# B787 Fuel Pump Technical Update - F202

Boost Pump P/ N 39-0001-1400

### Trickle Impregnation of varnish insulation on Stator Windings

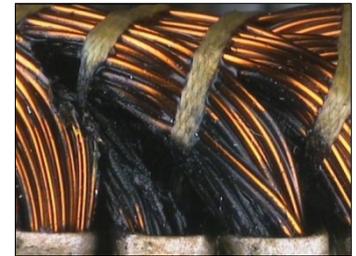
- Complete - serial number 01888 first part with this build improvement. Aircraft delivery May 2015 (Line 268)
